Yarralumla Residents Association

Analysis of two reports published in 2016 by Land Development Agency (LDA) as part of the Canberra Brickworks Precinct Development (CBP)

January 2017

Report Concept Plan- Recommended Solution

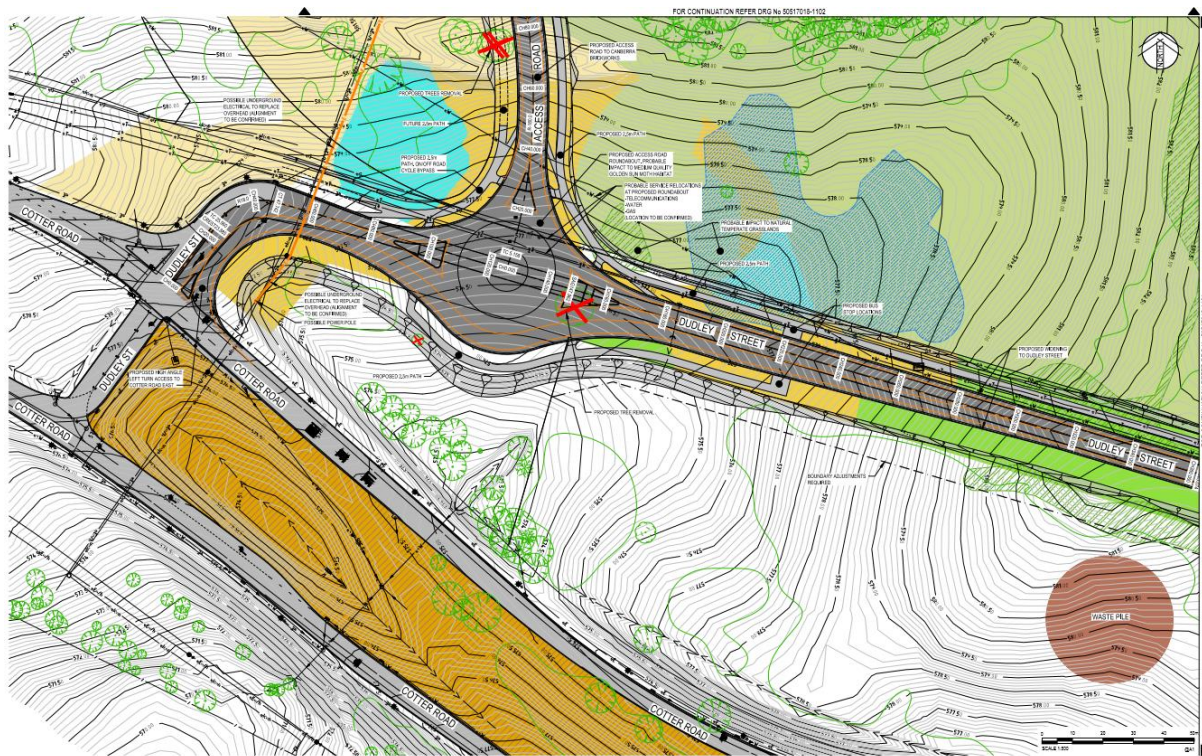
Dudley Street currently varies in width, being only single lane each way and 6 m wide over most of its length, equating to an Access level A and B road (Estate Development Code) but carries arterial road volumes of traffic and is classified by ACT Roads as a Major Collector. It is proposed that Dudley Street be upgraded to:

- a 10m wide carriage way width associated cycle paths and pedestrian path and verges making a total width of 26m
- at the Cotter Road end of Dudley Street, it is proposed that there be two lanes each way to the roundabout making the total width some 36m

- Removal of the pedestrian island at the Novar Street intersection is proposed to allow buses to turn.

- the roundabout starts approximately 90m from the Cotter Road intersection and in total covers an area about 100m in diameter
- The alternative of an un-signalised Tee Intersection was assessed but not preferred as there was a LOS F for the minor leg (CBP Access Road) in the PM Peak period (cf Annex 2 p 16). A Tee intersection with signals was not assessed.

Figure 2 CBP Proposed Access Road and cutting through Ridge, Woodland and Uriarra Track

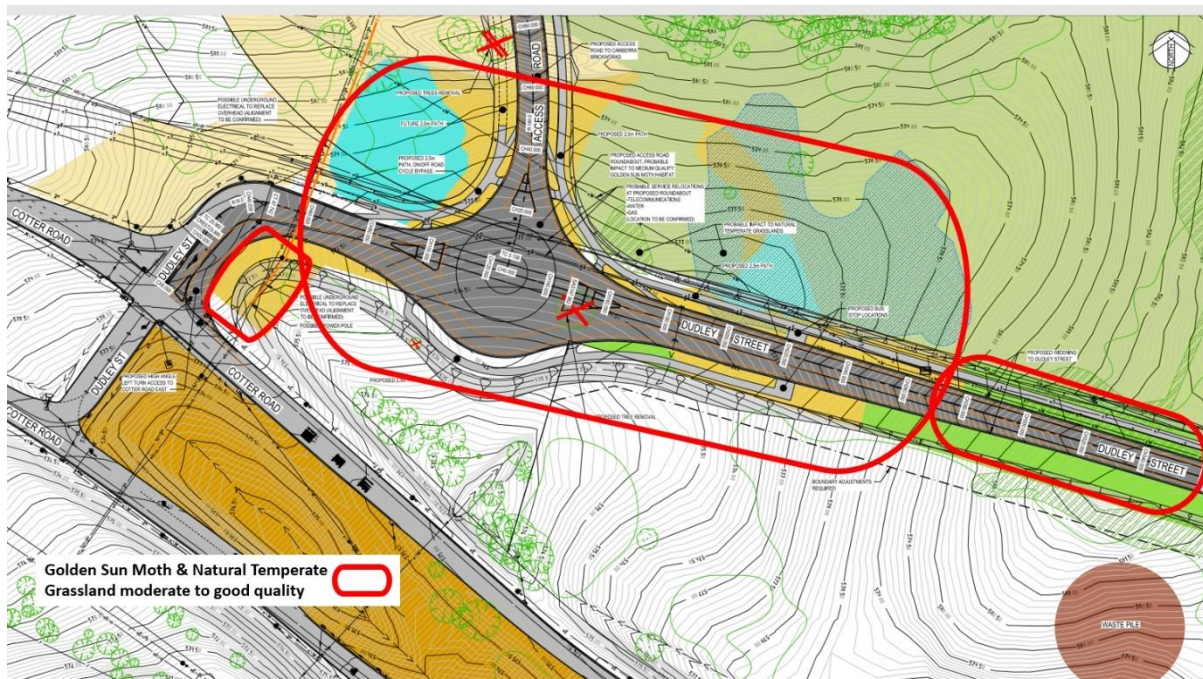
- is a Minor Collector at 10m wide carriageway with associated cycle paths and pedestrian path and verges making a total width of 26m will be level requiring a significant cutting through the ridge line which takes the out to a width of more than 30m
- the alignment of the road is NOT along the existing electricity powerline but some 75m further east

- requires the removal of a large number of high value trees in particular the oak trees and indeed the removal of the majority of trees is proposed
- puts about a 7m deep cutting through the existing east-west wooded ridgeline that is a landscape scale asset on Urban Open Space that is Designated Land and forms part of an Approach Route under the National Capital Plan. This will severely disrupt the terrain and geological features and impact on the natural vista of the Approach Route with a deep scar

- bisects the highly valued woodland walking trail and Old Uriarra Tract with a 30m plus wide and about a 7m deep cutting. This will totally disrupt the “Green walking circuit” and makes providing a continuous crossing of the CBP Access Road highly problematic
